# Addendum to Preliminary & Final Drainage Report

## **Sanctuary of Peace Residential Community**

**Project Number 61087**

**PCD Proj # SF-21-27**

**PROPOSED DRAINAGE MAP**

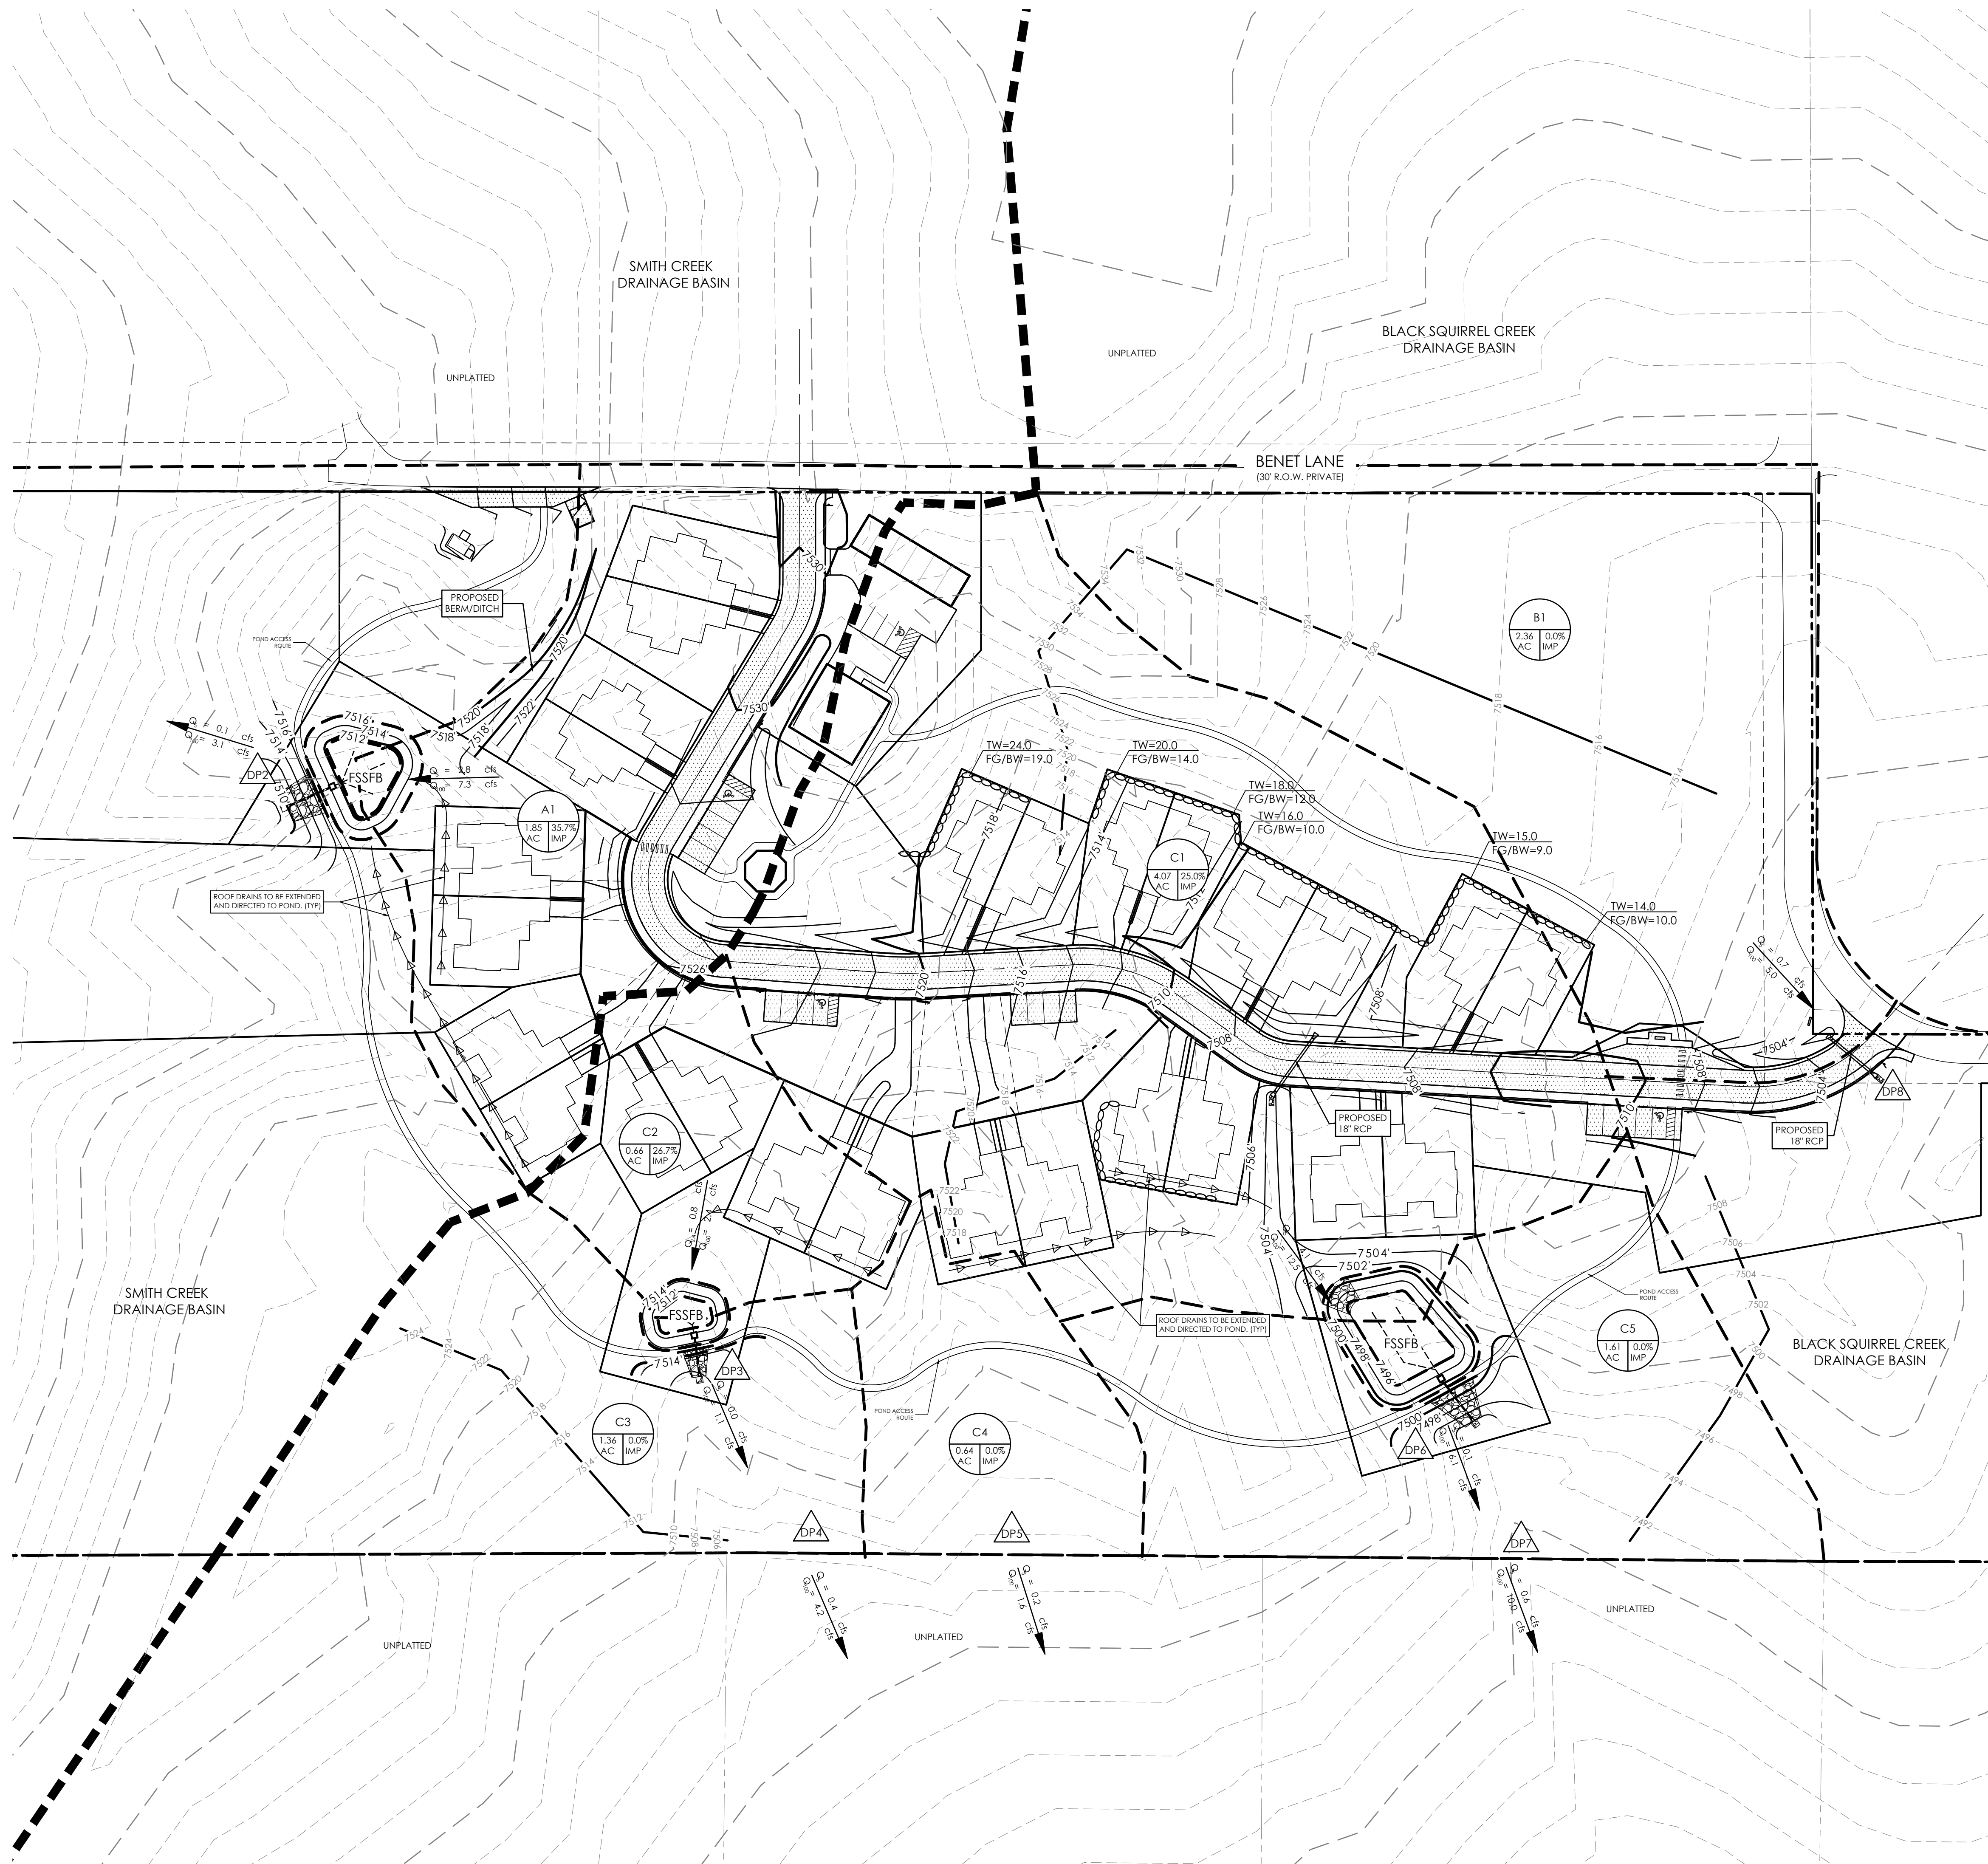
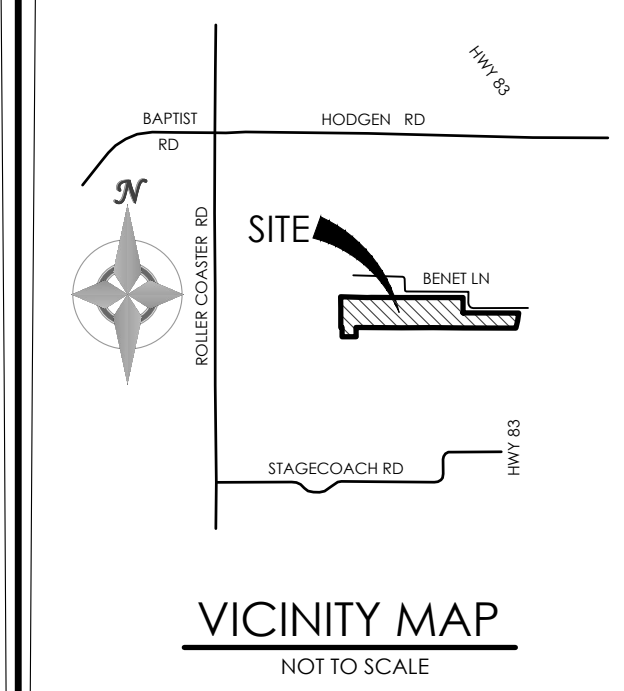
**The existing flows at DP EX9, which includes sub-basins OS C, EX-B1 and EX-B2 are 19.1 cfs and 106.5 cfs for the 5-year and 100-year rainfall recurrence intervals, respectively. Developed Condition** Design Point DP9 has storm water flows from Drainage Basin OS C and will flow overland to Benet Lane (private drive) and under Benet Lane via existing culverts. These storm water flows will combine with DP8 and overland flows from Basin B2. This area remains in its existing state of forested land. The rate of flow is  $Q_5 = 19.7$  cfs and  $Q_{100} = 108.3$  cfs and exits the site along its southerly boundary designated as Point of Interest DP9. **This represents minor changes in flow rates of 0.6 cfs in the 5-year and 1.8 cfs in the 100-year events.**

DESIGN POINT	BASIN	AREA (AC)	Tc (MIN)	RUNOFF	
				Q5 (CFS)	Q100 (CFS)
	OS A	69.40	41.9	11.4	81.1
	OS B	83.92	41.7	17.4	102.7
	A1	1.85	9.1	2.8	7.3
	A2	28.30	27.7	5.9	43.3
DP1	OS A, OS B, DP2, A2	183.47	41.9	34.8	230.2
DP2 In	A1	1.85	9.1	2.8	7.3
DP2 Out	A1	1.85	9.1	0.1	3.1
	C2	0.66	8.8	0.8	2.4
DP3 In	C2	0.66	8.8	0.8	2.4
DP3 Out	C2	0.66	8.8	0.0	1.1
	C3	1.36	11.8	0.4	3.1
DP4	C2, C3	2.02	11.8	0.4	4.2
	C4	0.64	8.8	0.2	1.6
DP5	C4	0.64	8.8	0.2	1.6
	C1	4.07	13.1	4.1	12.5
DP6 In	C1	4.07	13.1	4.1	12.5
DP6 Out	C1	4.07	13.1	0.1	6.1
	C5	1.61	10.2	0.5	3.9
DP7	C1, C5	5.69	13.1	0.6	10.0
	B1	2.36	14.4	0.7	5.0
DP8	B1	2.36	14.4	0.7	5.0
	B2	9.23	11.8	3.4	21.7
	OS C	49.12	23.0	16.9	89.9
DP9	B1, B2, OS C	60.72	23.7	19.7	108.3
